WOLF CREEK

Subject: Docket No. 50-482: Revision to Technical Specifications
3/4.8.2.1, 3/4.8.2.2, 3/4.8.3.1 and 3/4.8.3.2 - Electrical
Power Systems - D.C. Sources and Onsite Power Distribution

This letter transmits an application for amendment to Facility Operating License No. NPF-42 for Wolf Creek Generating Station (WCGS). This license amendment request proposes to revise the 125-volt D.C. Sources Technical Specifications (3.8.2.1 and 3.8.2.2) to include provisions for installed spare chargers, which will be added to the plant design during the next refueling outage. The Onsite Power Distribution Technical Specifications 3.8.3.1 and 3.8.3.2 would be revised to indicate that spare chargers may be connected in place of the primary chargers.

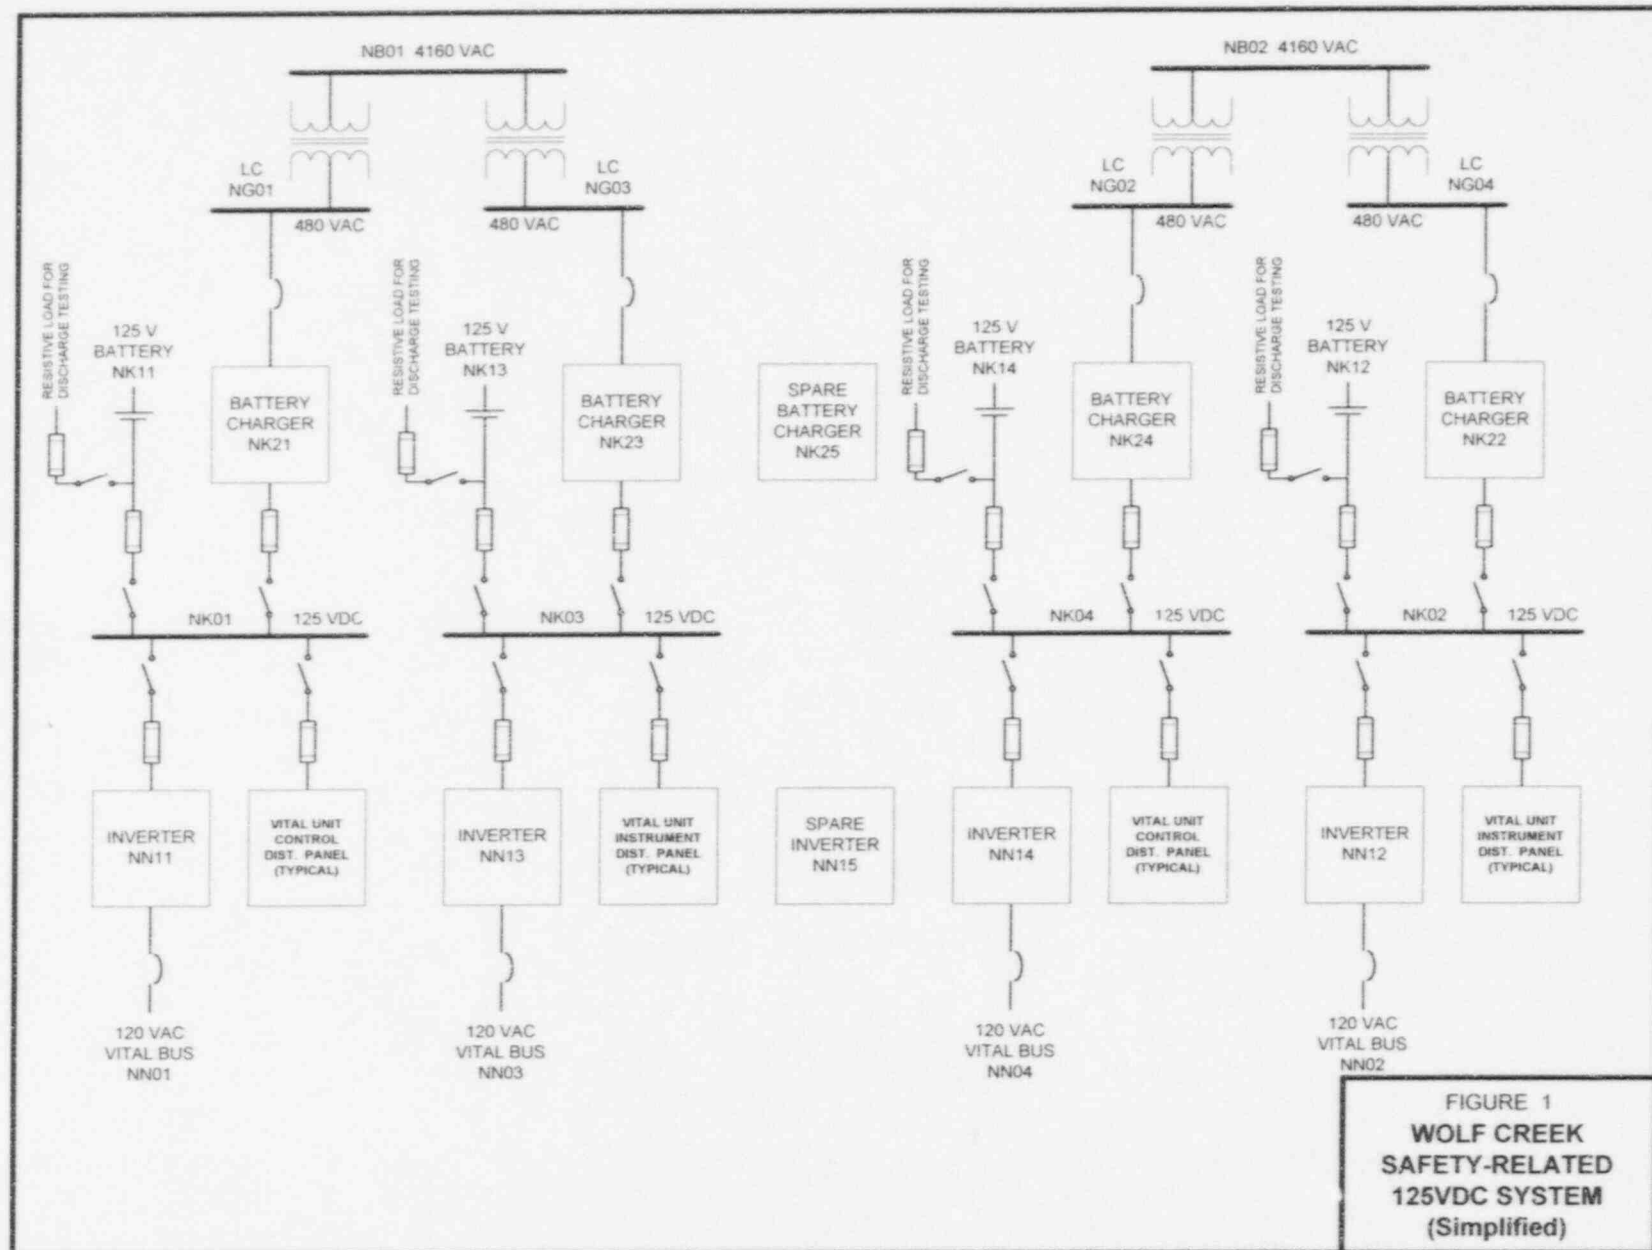
Figure 1 is a simplified drawing of the safety-related 125-volt D.C. system at Wolf Creek Generating Station. This figure shows the connections from the two 4160-volt A.C. Emergency Busses (NB01 and NB02) through the four 480-volt A.C. Emergency Busses (NG01/NG03, NG02/NG04). The NG busses supply power to the four full capacity chargers (NK21/NK23, NK22/NK24). Each charger supplies a Class 1E 125-volt D.C. bus (NK01, NK03, NK02, and NK04) and an associated 125-volt battery bank (NK11, NK13, NK12, or NK14).

The Class 1E D.C. system provides D.C. electric power to the Class 1E D.C. loads and for control and switching of the Class 1E systems. Physical separation, electrical isolation, and redundancy are provided to comply with the requirements of IEEE Standard 308. The four Class 1E D.C. power subsystems are shown in Figure 8.3-6, Sheet 1, of the Updated Safety Analysis Report (USAR). Subsystems 1 and 4 provide control power for A.C. Load Groups 1 and 2, respectively. These subsystems also provide vital instrumentation and control power for channels 1 and 4, respectively, of the reactor protection and engineered safety features systems. D.C. subsystems 2 and 3 provide vital instrumentation and control power for channels 2 and 3, respectively, of the reactor protection and engineered safety features systems. Each Class 1E D.C. power subsystem consists of one 125-volt battery, one battery charger, one inverter, and distribution switchboards. The battery chargers for D.C. subsystems 1 and 3 are supplied 480-volt A.C. power from different Class 1E busses of Load Group 1. Similarly, the battery chargers for D.C. subsystems 2 and 4 are supplied 480-volt A.C. power from different

Currently, one spare battery charger and one spare inverter are provided for the power block. These items are physically located central to all of the Class 1E D.C. systems. They are not, however, electrically connected. In the event of the failure of a charger or inverter, the spare is manually connected to the affected system. Therefore, the malfunctioning equipment may be repaired without imposing long-term disruption of the system. A design change to be implemented during the eighth refueling outage to permanently install seismically qualified spare chargers is described below.

The modification to be implemented during the eighth refueling outage will provide permanently installed spare chargers for the 125-volt D.C. system (Reference Figure 2).

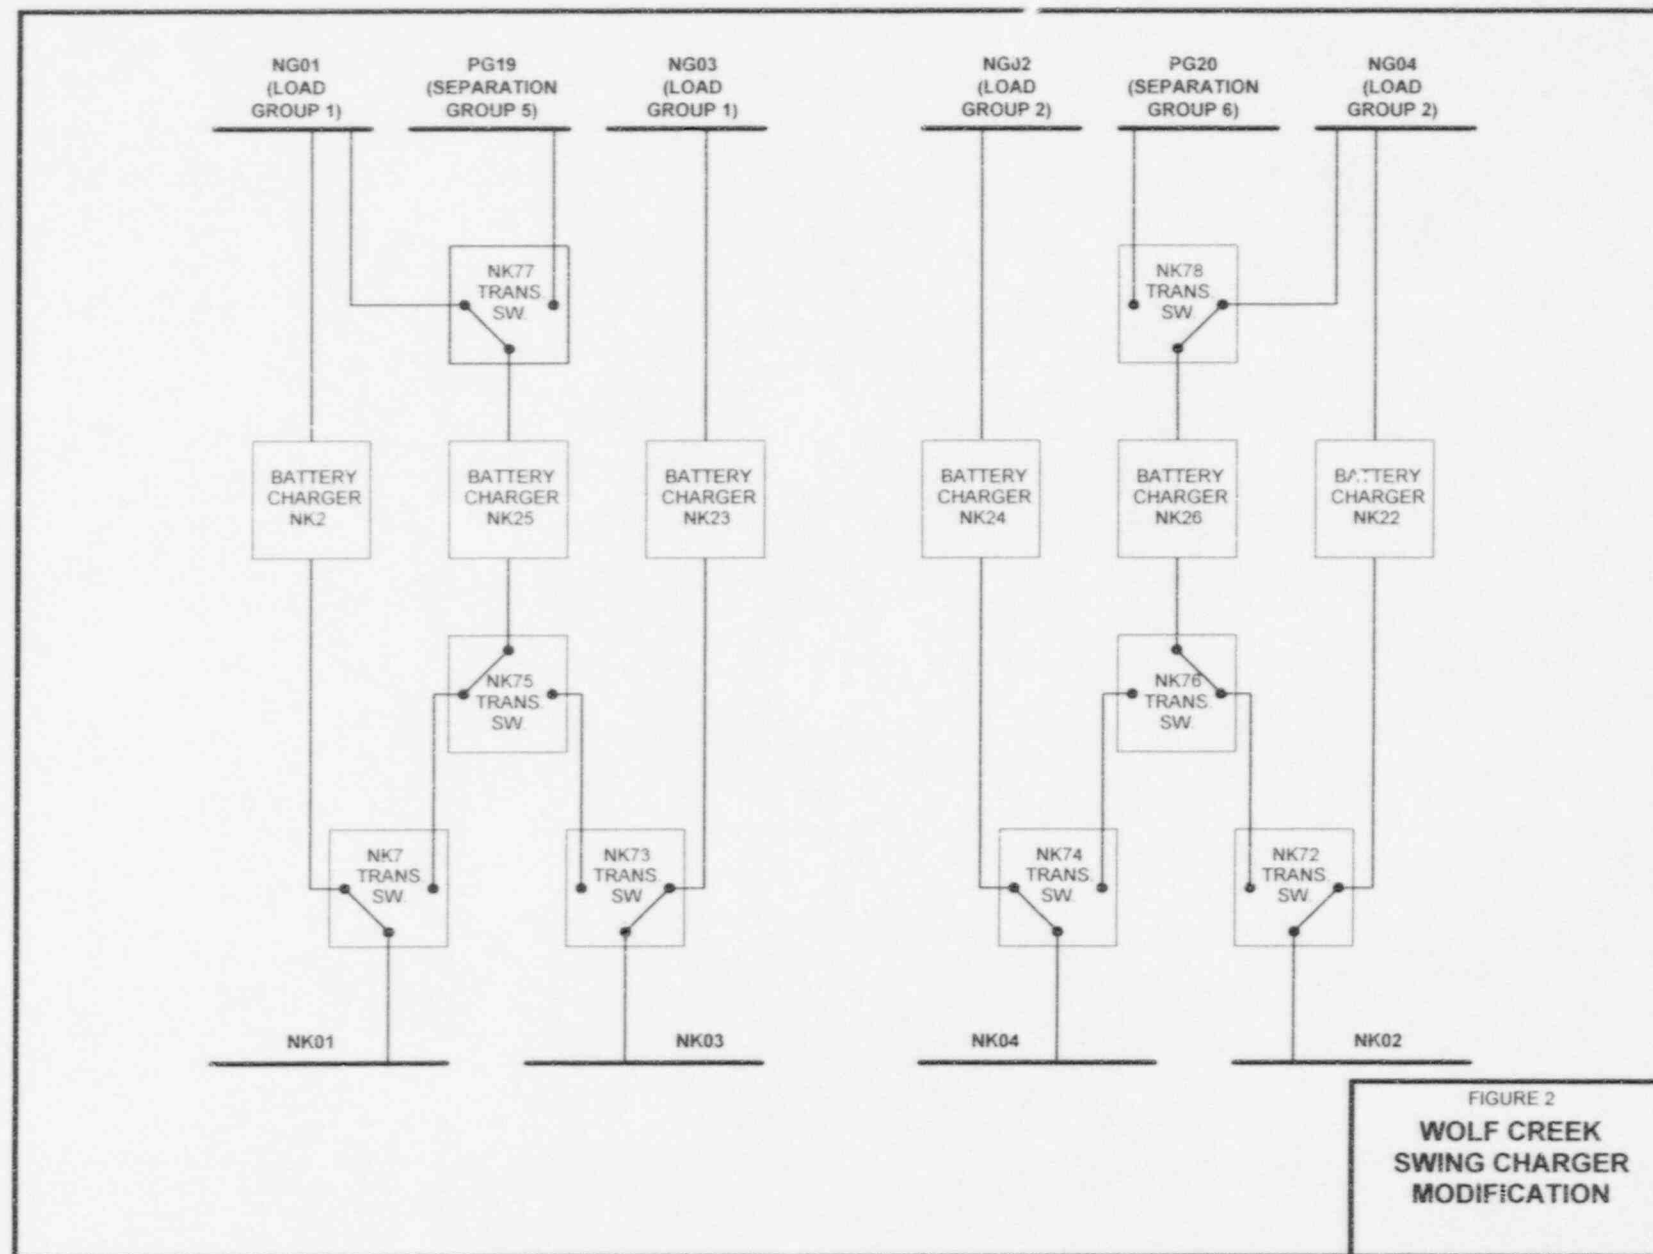
The current spare battery charger will be permanently installed as a spare swing charger for the 125-volt D.C. Busses NK01 and NK03. A new charger will be installed as a spare swing charger for 125-volt D.C. Busses NK02 and NK04. Each Class 1E D.C. power subsystem will then consist of one 125-volt battery, one primary battery charger, one inverter, distribution switchboards, a shared swing battery charger, and swing battery charger transfer switches. The battery chargers for D.C. subsystems 1 and 3 will be supplied 480-volt A.C. power from different Class 1E busses of Load Group 1 while their shared swing battery charger will be supplied 480-volt A.C. power from either a Class 1E bus of Load Group 1 or a Non-class 1E bus from Separation Group 5. Similarly, the battery chargers for D.C. subsystems 2 and 4 will be supplied 480-volt A.C. power from different Class 1E busses of Load Group 2 while their shared swing battery charger will be supplied 480-volt A.C. power from either a Class 1E bus of Load Group 2 or a Non-class 1E bus from Separation group 6.

Two swing battery charger subsystems will be provided for the Class 1E D.C. power subsystems. One for use with Class 1E D.C. subsystems 1 and 3 and the other for use with Class 1E D.C. subsystems 2 and 4, permanently connected to their respective Class 1E D.C. power subsystems via manually controlled, electrically operated, transfer switches. In the event of a failure of a primary battery charger, the respective swing battery charger can be quickly aligned to provide power to the affected D.C. power subsystem. Therefore, the malfunctioning equipment may be repaired without imposing long-term disruption of the system. Once the swing battery charger is aligned to a given D.C. power subsystem all of the required annunciated trouble conditions are monitored on the swing charger and an annunciator window on the main control boards is lit to alert the control room staff that a swing charger is in use.

Both specifications would be modified to indicate that spare charger NK25 may be connected in place of charger NK21 or NK23 and spare charger NK26 may be connected in place of charger NK22 or NK24.
